Final Drainage Report The Rock Commerce Center

PCD File No. PPR2329

July 28, 2023
October 20, 2023
November 17, 2023
December 15, 2023
Project No. 23009.001

DETENTION BASIN OUTLET STRUCTURE DESIGN

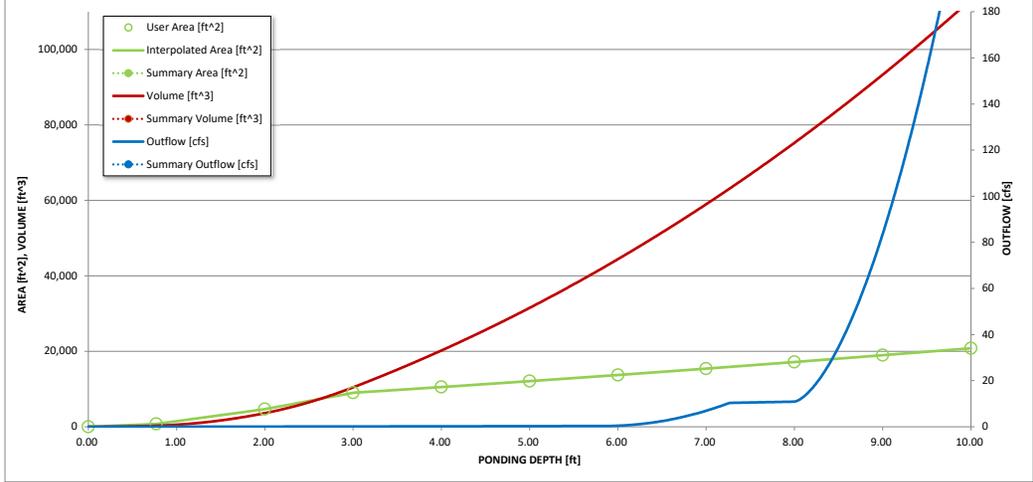
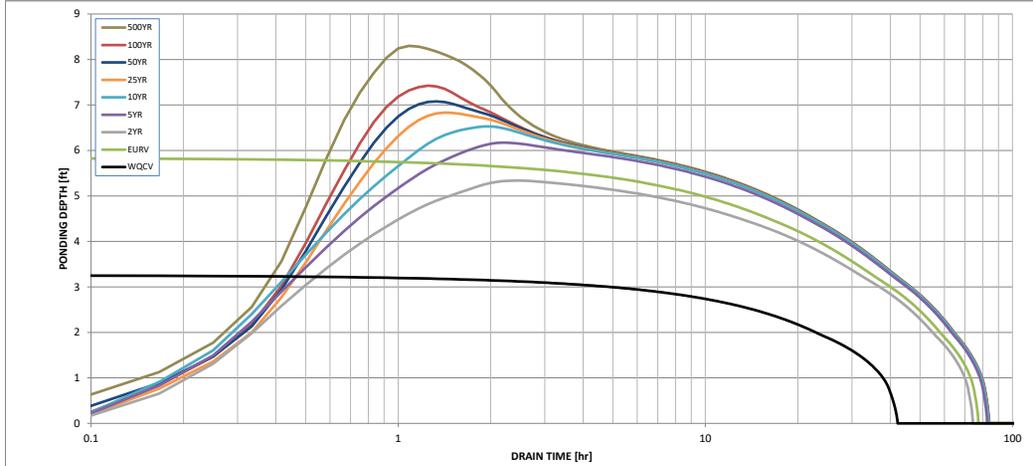
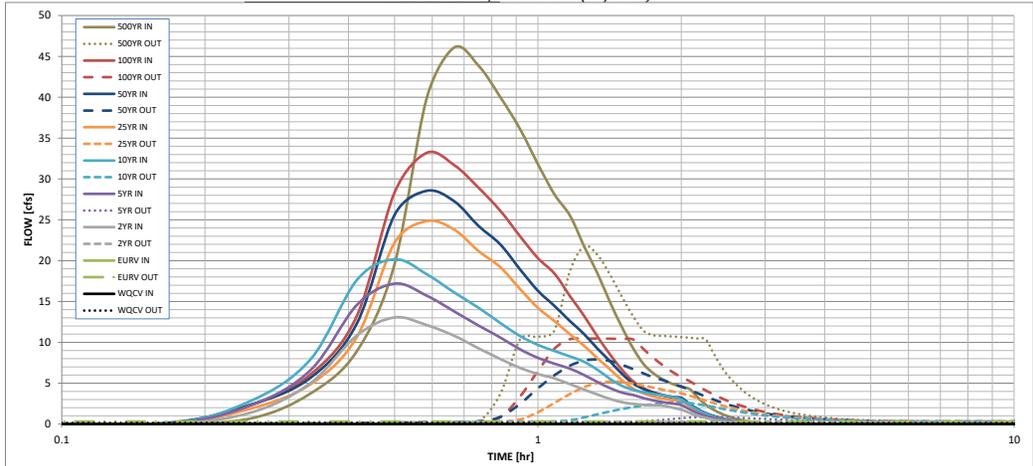
Please include sheet for inlets 1-3 as done in previous submittal.
